In which a member of the public comments on a Proposed Action in WMNF...

In its Small Projects Day application to WMNF Eversource states:

“Eversource, current permit holder for utility lines across the WMNF, has identified five existing utility poles that need to be replaced within the existing right of way (ROW) of the X178-1 transmission line in Campton, Thornton, and Woodstock, NH.”

Below: Eversource complete rebuild, O-154 line, Stark, N.H. Note permanent road and construction pads, both bermed with glacial erratics and rip-rap and covered with gravel.

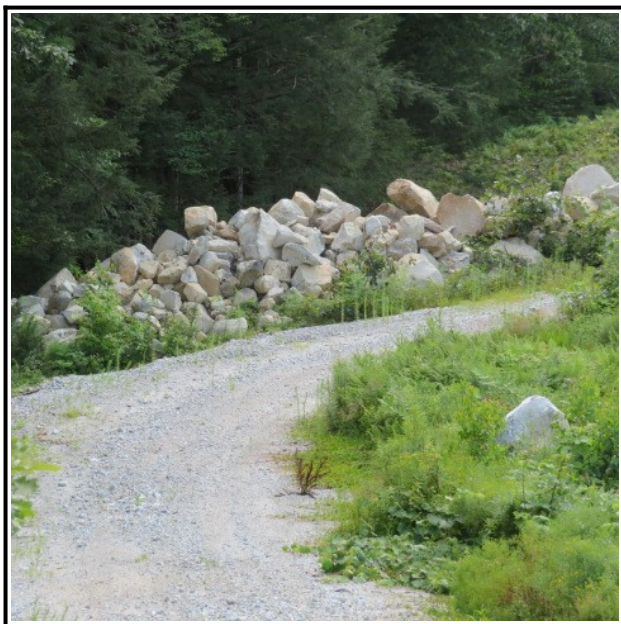
Why steel, which has a high carbon footprint and industrializes the easement, especially if you see the structures from within the easement rather than from a road or highway? Eversource states that steel is lighter than wood, yet claims its contractors need to use high-impact construction methods: 16’ wide permanent roads from which topsoil and plants have been removed, and 100’ x 100’ permanent construction pads; leveled, topsoil removed, and rip-rap, gravel and glacial erratics used for berms. Both the roads and pads will cause land fragmentation and degradation, increased run-off, and illegal use of the easement. (2/4/2024)

Can the steel structures have the upper section replaced with a taller one, for future “incremental” (15’) height increases?

Above and below, Eversource equipment on line rebuilds, 2/14/2024 and 2/4/2024

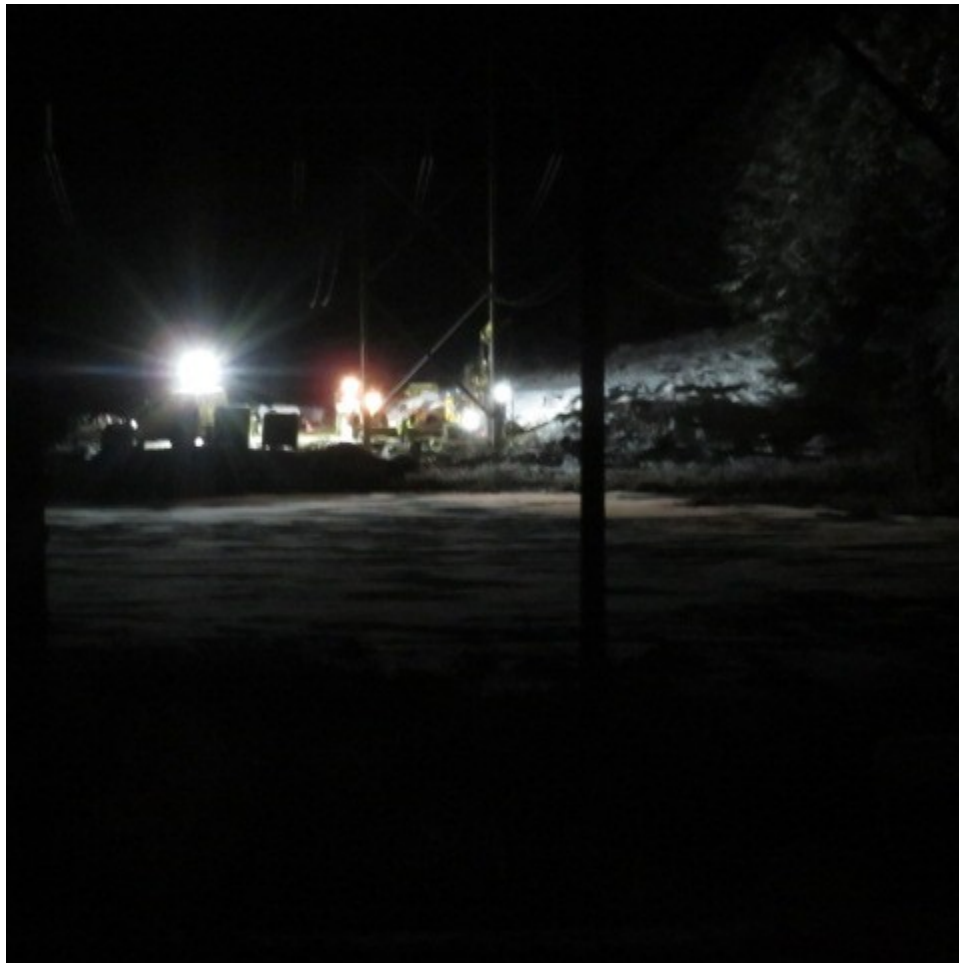
Eversource states: “Vehicles and equipment that will need to access the transmission line corridor include mobile cranes to set poles, flatbed trucks to deliver materials, and other mobile equipment such as drill rigs, front-end loaders, and excavators.

The project proposes to use portions of two existing roads outside of the ROW for access. Grading and the addition of gravel may be necessary to make access roads off the ROW passable by construction equipment.”

Neither Eversource nor the Forest Service provided maps of the proposed access roads outside the easement, nor of the project location and plans.

Below: the section of the X-178 covered in Eversource’s Small Projects Day application.

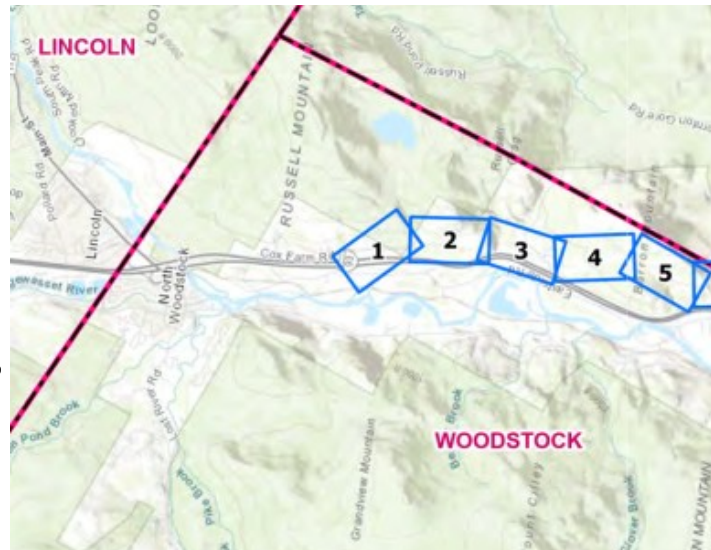
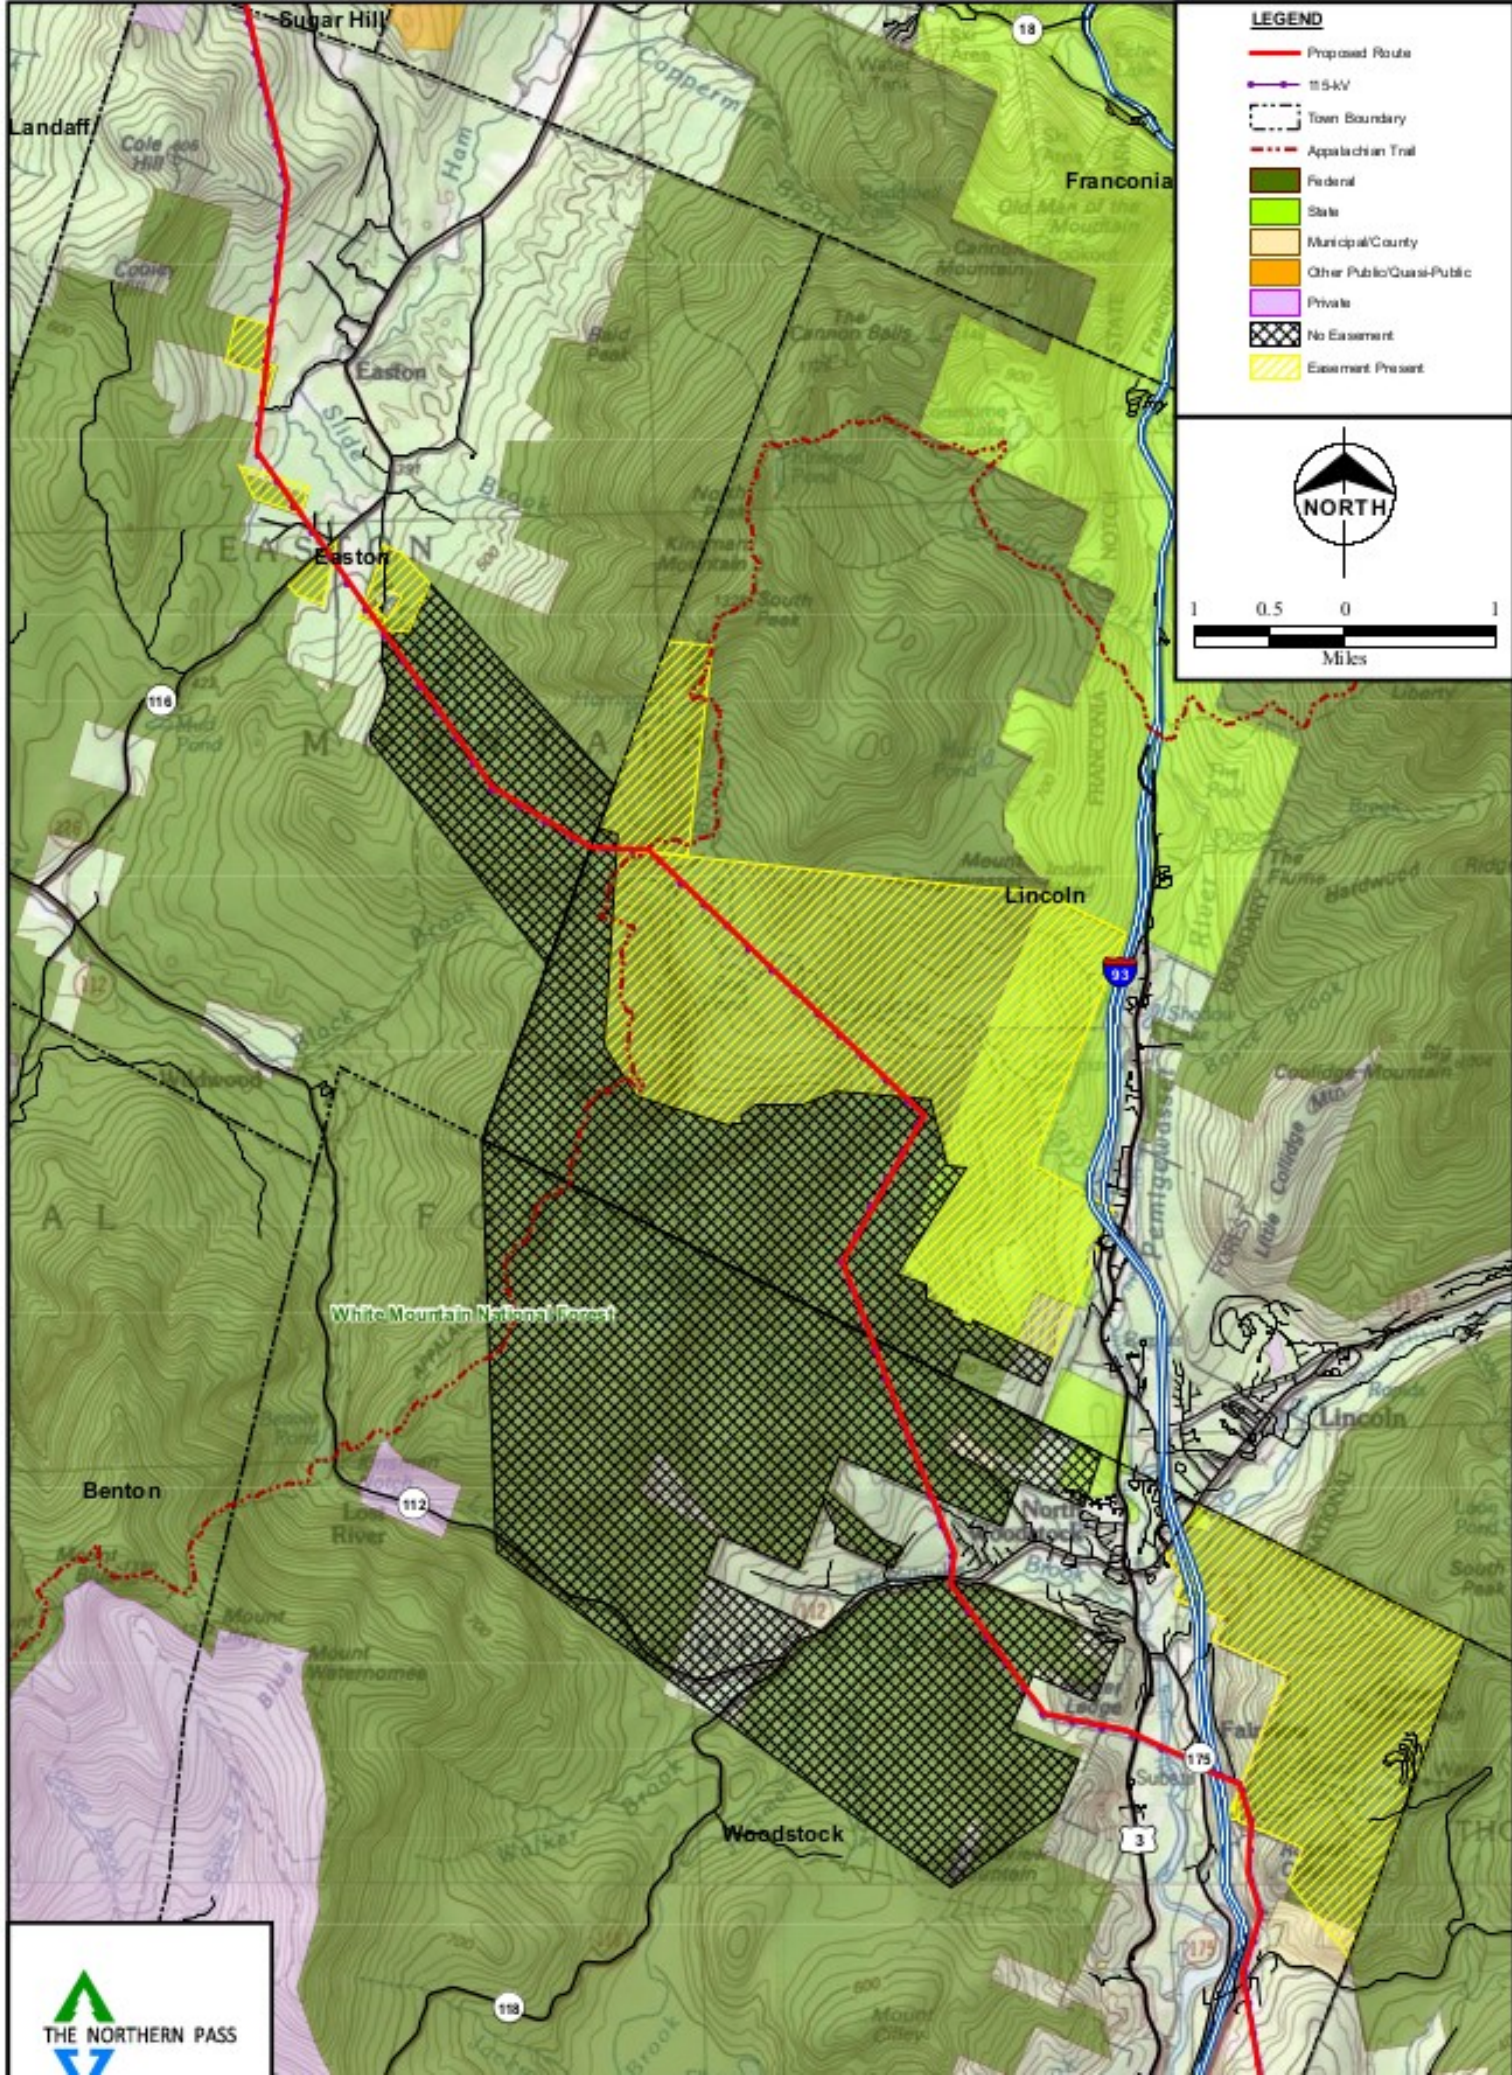
Section shown above is from Map 1 in Eversource’s section 1 map set. The X-178 easement continues northwest on the Section 2 map set which covers more of the easement/SUP area in WMNF. (<-N)

Eversource repeatedly stresses the interdependence of its transmission lines, yet when it wants to complete construction of sections 1 and 3 of the X-178, and place pressure on the Forest Service to grant it a Special Use Permit for construction in Section 2, which holds the unique and environmentally sensitive Bog Pond area, it presents the X-178 as a project in which .28 miles (Eversource information) of the line can be considered unconnected to the other 48.72 miles. It states that a Special Use Permit is not required for this construction, despite its knowledge of the SUP. Perhaps Eversource representatives should be under oath when filling out federal forms, and at the PAC presentations.
